# Duquesne Light Company

Reference: Beaver Valley Power Station, Unit No. 2  
Docket No. 50-412, License No. NPF-73  
Feedwater Regulating Valve Plug Material;  
Proposed Alternative to 10 CFR 50.55a(g)

ASME III CONTROL VALVE DISC MATERIAL INQUIRY

FIGURE 1

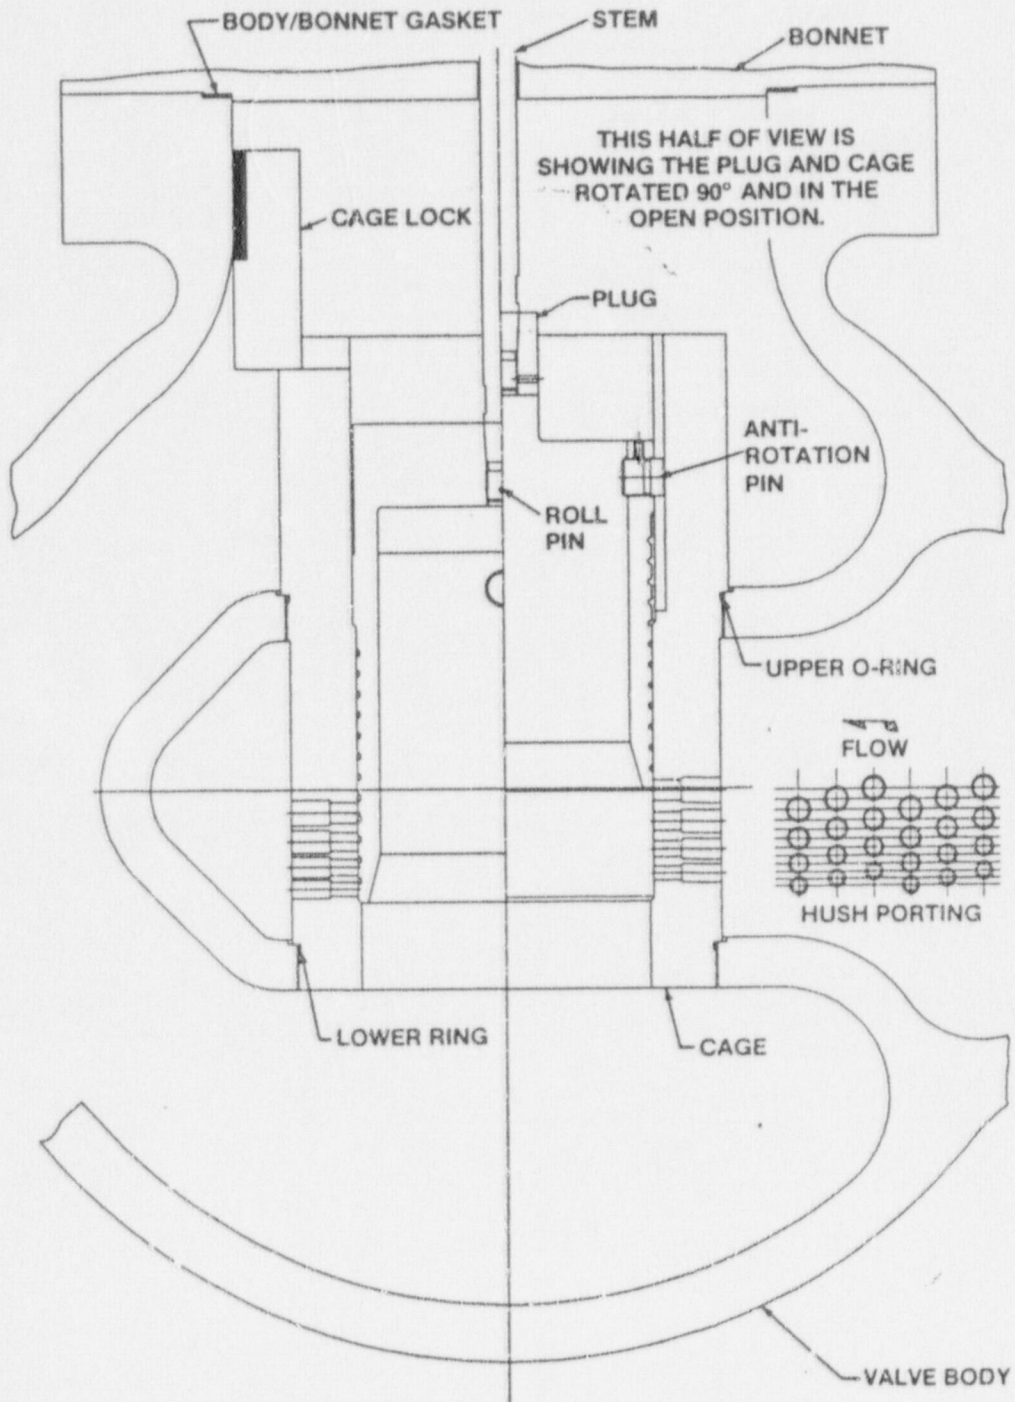
During Unit No. 2's first operating cycle, these feedwater regulating valves showed significantly greater wear and deterioration than was expected. Figure 1 is a sketch of the Copes-Vulcan 12 inch Class 900 valve used at Unit No. 2. The excessive wear is associated with the anti-rotation pins which are designed to prevent the plug from rotating within the cage and potentially disengaging from the valve stem. Similar problems had been encountered in Unit No. 1 and were successfully corrected by utilizing a Type 420 SS material for the valve plug and anti-rotation pins.

The purpose of this letter is to request approval under the provisions of 10 CFR 50.55a(a)(3) to use Type 420 Stainless Steel material for plugs in the Beaver Valley Unit No. 2 main feedwater regulating valves. The reason for this material change is to eliminate the excessive wear found on the original components. This was initially discussed on April 6, 1989, with Mr. R. Hermann and Mr. P. Tam of the NRC's staff and Mr. S. Sovick of my staff.

**SHRINK FIT  
STYLE #5**

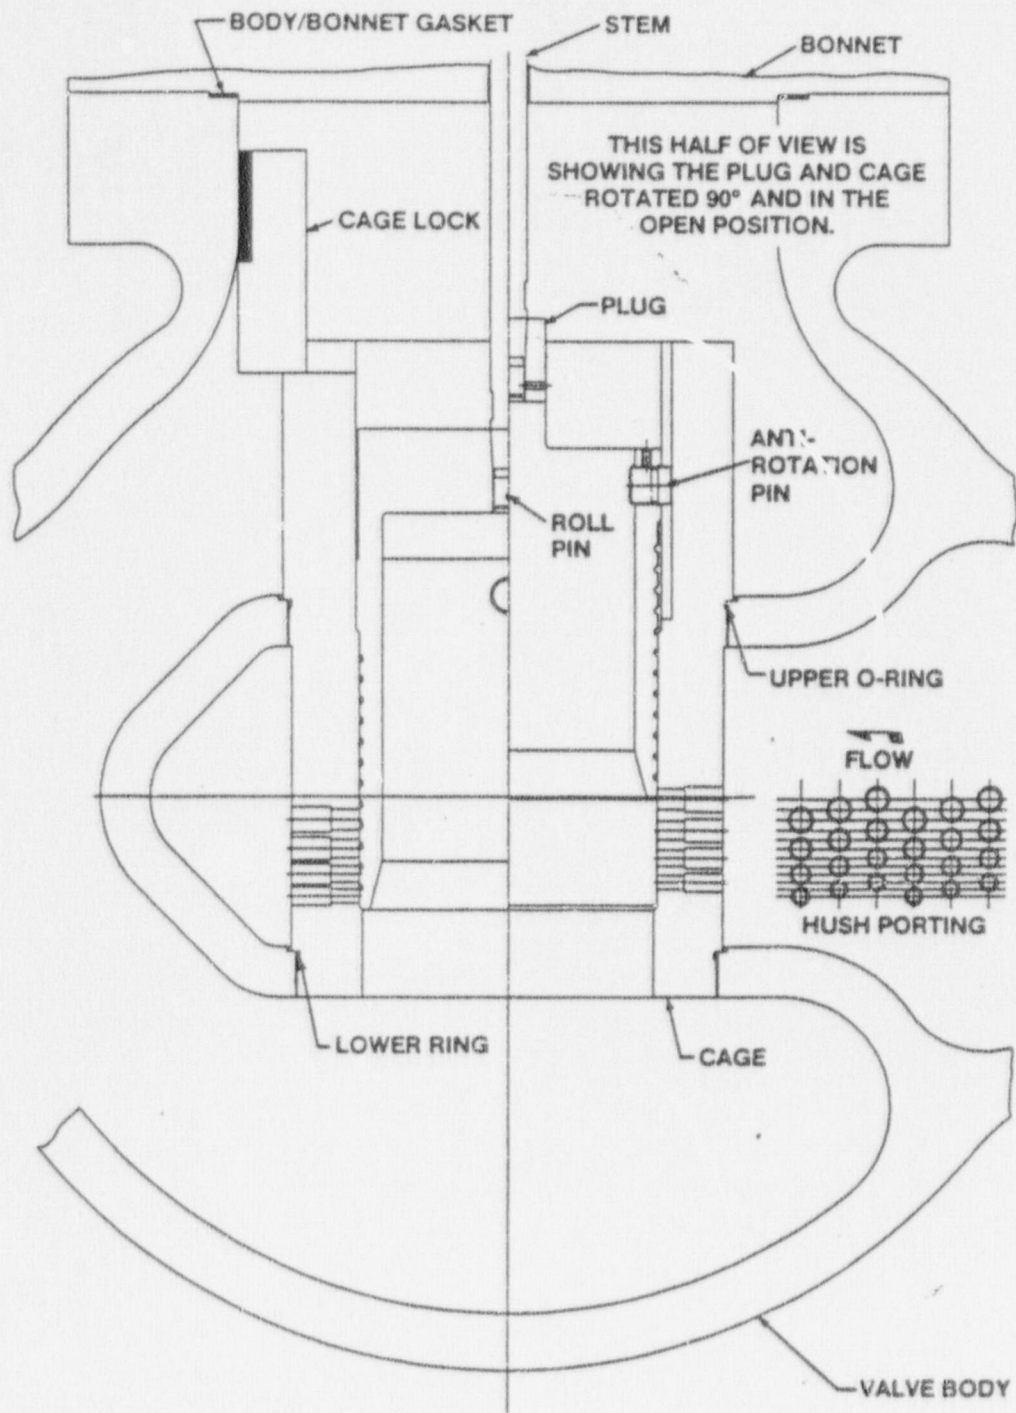
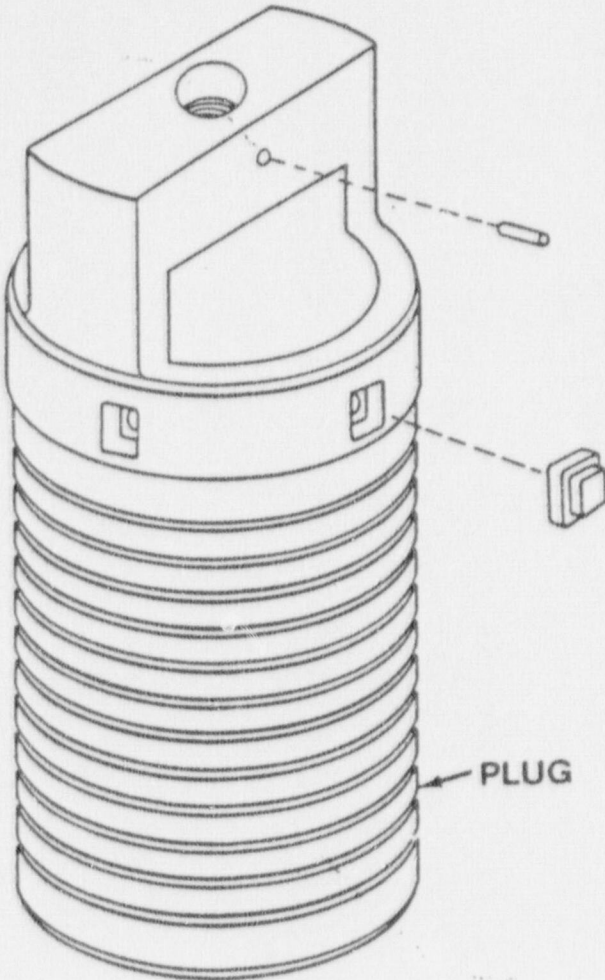
Since startup of Unit No. 1 in 1976, the main feedwater regulating valves have gone through a number of modifications to the trim in an effort to improve valve reliability. In 1983, the present configuration was installed which was essentially a cavitation control design made of ASTM A 276, Type 420 SS cage and plug. This was acceptable since the Unit No. 1 feedwater piping was constructed to the ANSI B 31.1 Power Piping Code. From that time to the present, the three (3) main feedwater regulating valves' reliability has shown remarkable improvement in its wear resistance capability, especially around the anti-rotation pin area of the plug. This is the location where most wear has been experienced.

Review of the maintenance history for these valves since 1983 shows that most repair/replacement activities occurred during the period from 1983 to 1985, when the anti-rotation pins' design was changed from a mechanical attachment joint to a shrink fit arrangement. Since 1986, the valves have performed well with little maintenance related to the present trim/anti-rotation pin design. Recent inspections have shown excellent wear resistance by the ASTM A 276, Type 420 SS plug and anti-rotation pins.
